# **Russell Gap Stream Mitigation Project Year 1 (2020) Monitoring Report FINAL**

DMS Project ID No. 100003, DEQ Contract No. 6980

**Subject:** Response to DMS Comments for DRAFT MY1 Report  
Russell Gap Mitigation Project, Alexander County  
DMS Project # 100003, DEQ Contract #6980, Catawba River Basin

Figure 6. Flow Gauge Graphs

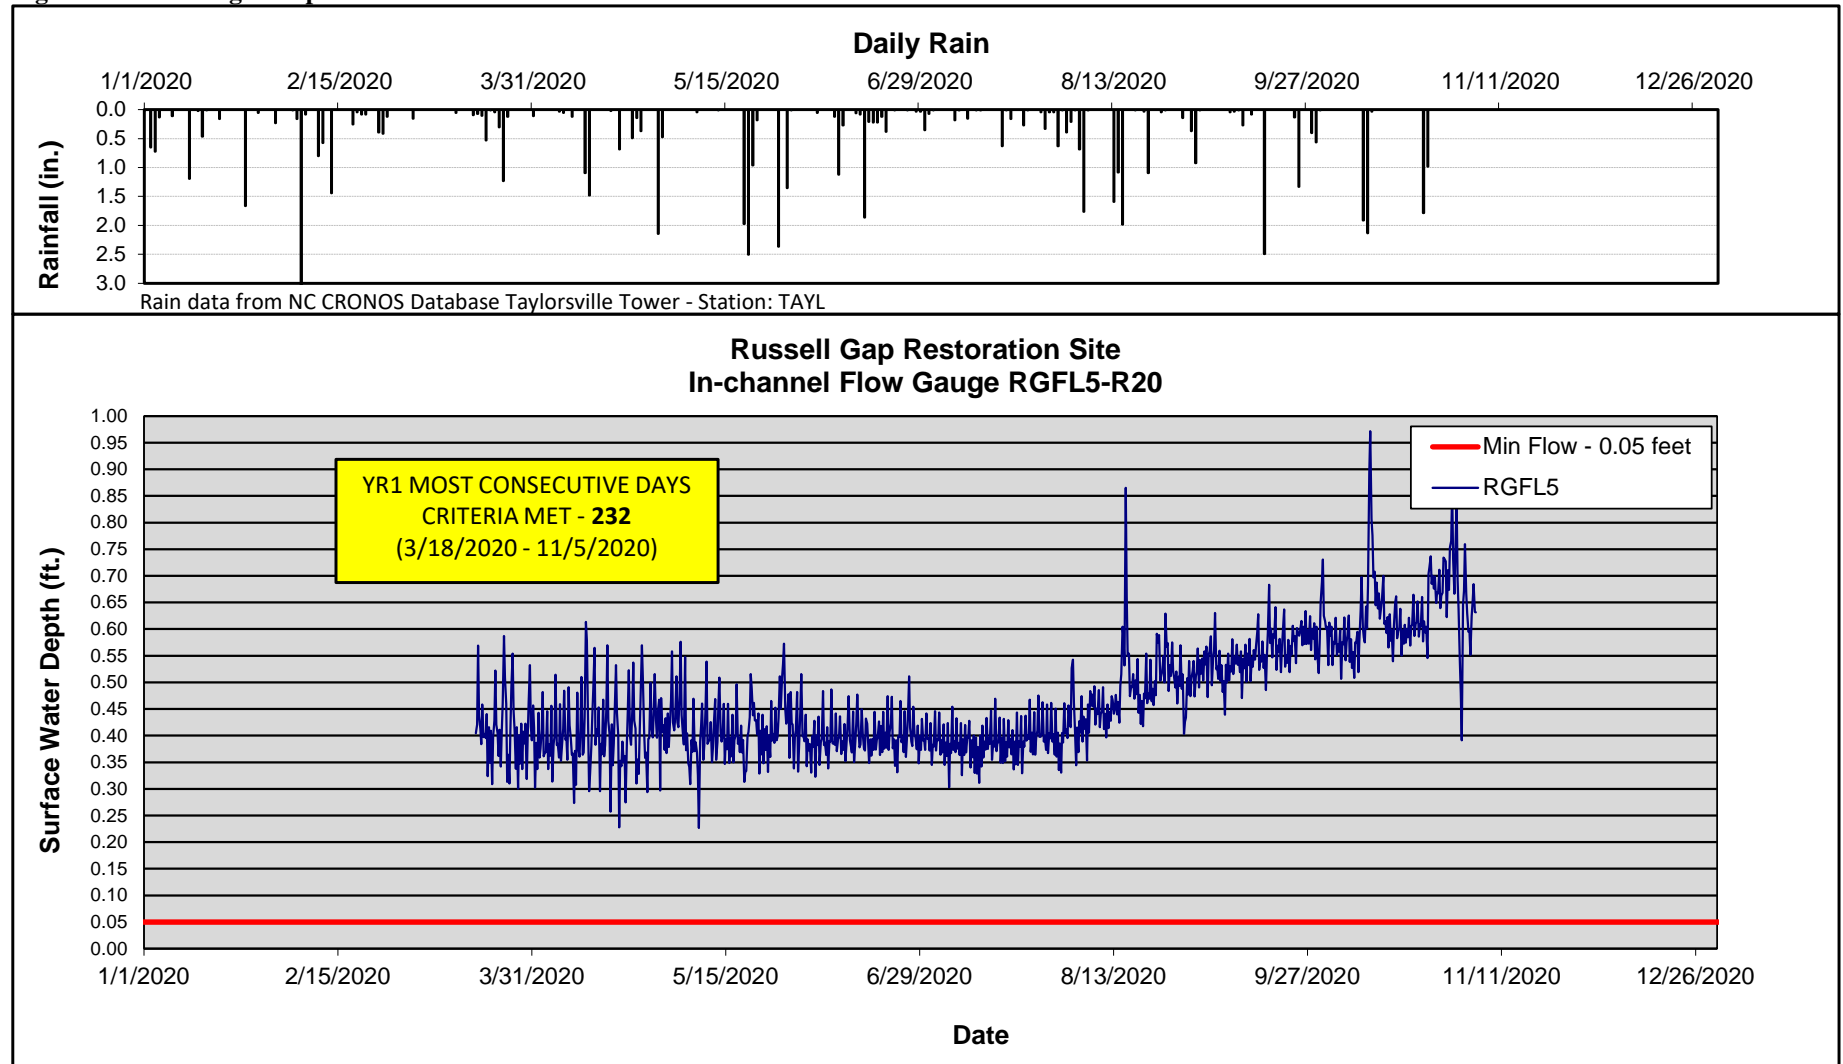
**Response: Revision made as requested.**
- Flow Gauge Graphs: The note for the Daily Rain portion indicates data is from onsite gauge from the Browns Summit site. Please revise.

**Response: Revision made as requested.**
- Figure 7: Please use bars for the “Observed Project Rainfall”.  
**Response: Revision made as requested.**
- Figure 7: Please specify what weather station(s) was used to compile data.
